Service Letter: 418 (page 1 of 5) Revision A

Title: Electrical System Update

Applicable All Model 7FC, 7GC, 7HC, 7GCA, 7JC, 7GCB, 7KC, 7GCBA, 7KCAB, and 7ACA

Figure 1 Schematic of Primary Electrical System (Aft Mounted Battery) Before Modification

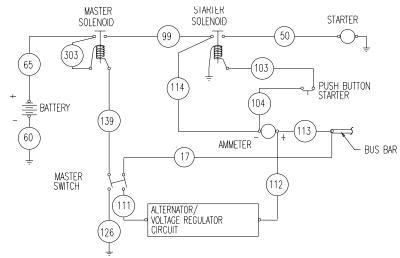
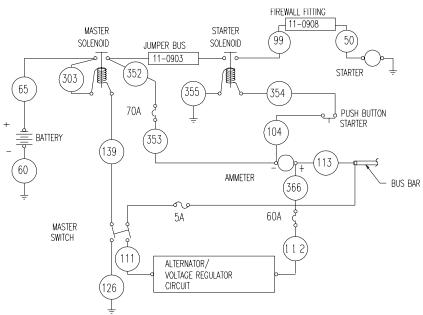
schematic in figure 1. The diagram has been simplified to show only the affected areas. Upon inspection, it can be seen that there is no circuit protection for the voltage regulator circuit before the voltage regulator. This wire is in a bundle with other critical wires and is a source of concern. Also, the circuit from the battery to the bus bar is not protected. This was due to the 'sharing' of a line to the starter. To accommodate circuit protection for these two circuits,

the electrical system must be modified to look similar to figure 2.

The first item that needs to be modified is the voltage regulator circuit. Wire number 17 must be replaced with an inline 5-amp fuse. This is a very short wire inside the electrical panel that runs from the bus bar to the alternator half of the master switch. Note that the master switch is a single throw double pole switch and connecting to the <u>wrong</u> pole will ground the bus bar when the switch is thrown. This fuse can be butt spliced in place or new terminals can be installed depending on application.

Figure 3 Typical installation for a Firewall Mounted Battery

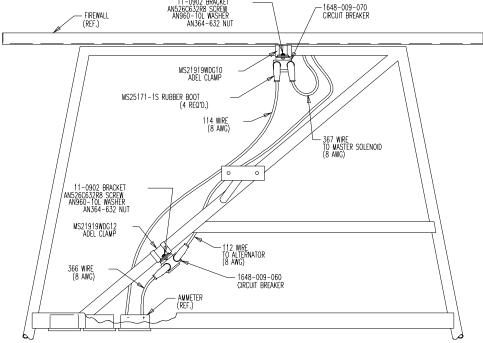
A properly installed firewall mounted battery requires the installation of circuit protection from the battery and the alternator. Mount the 70-amp battery circuit breaker inside the firewall using an Adel clamp and 11-0902 bracket. On the output side of the master solenoid, disconnect wire #114 and, mount wire #367 to the input (line) side of 70-amp circuit breaker. The wire #114 should then be attached to the output (load) side of the circuit breaker. Figure 3 depicts a typical installation.

Attach the 60-amp alternator circuit breaker to the diagonal fuselage tube with an Adel clamp and 11-0902 bracket. Disconnect the #112 wire from the ammeter and replace it with wire #366 attached to the input (line) side of the 60-amp circuit breaker. Attach alternator wire #112 to the output (load) side of the 60-amp circuit breaker. Figure 3 depicts a typical installation.

Figure 5 Typical Battery Board Installation

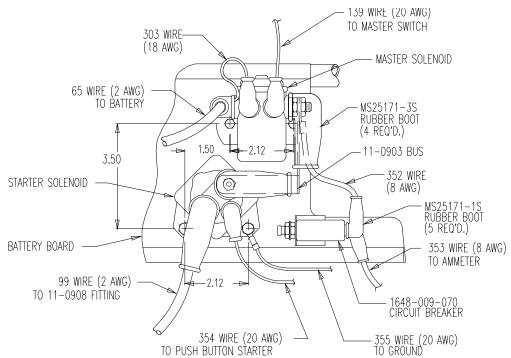
Remove the firewall fitting for wire #99 and push inside the airplane. Install fitting 11-0908 in the firewall in place of the former fitting. Mount wire #50 to the engine side of the fitting and wire #99 to the insulation side of the fitting. Use a rubber boot over each connection. The Assembly is depicted in figure 4. The starter solenoid should then be mounted to the battery board in close proximity to the master solenoid as depicted in Figure 5. This may require that the master solenoid be shifted as well. The wire #99 should be removed from the master solenoid and mounted to the starter solenoid. The 11-0903 jumper bus should then connect the two solenoids. The starter solenoid needs to be grounded if it is mounted on a wood battery board. Use wire #355 to connect to an appropriate ground. Route wire #354 up to the starter button in place of the former wire #103. Figure 5 depicts a typical installation.

Power to the bus bar from the battery must be restored by replacing wire #114. On the output side of the master solenoid, mount the short wire #352 to a 70-amp circuit breaker. Mount the breaker to the battery board using an appropriate bracket. This is also depicted in figure 5. Route the longer wire #353 to the ammeter in place of wire #114. The #353 and #354 wires should be bundled with wire # 99 to keep them away from fuel lines and control systems.

Figure 6 Under Dash Installation for Aft Mounted Battery

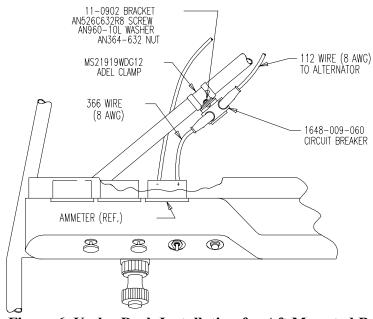
Disconnect wire #112 from the ammeter and replace it with wire #366 attached to the input (line) side of the 60-amp circuit breaker. Attach alternator wire #112 to the output (load) side of the 60-amp circuit breaker. Figures 5 and 6 depict a typical installation.
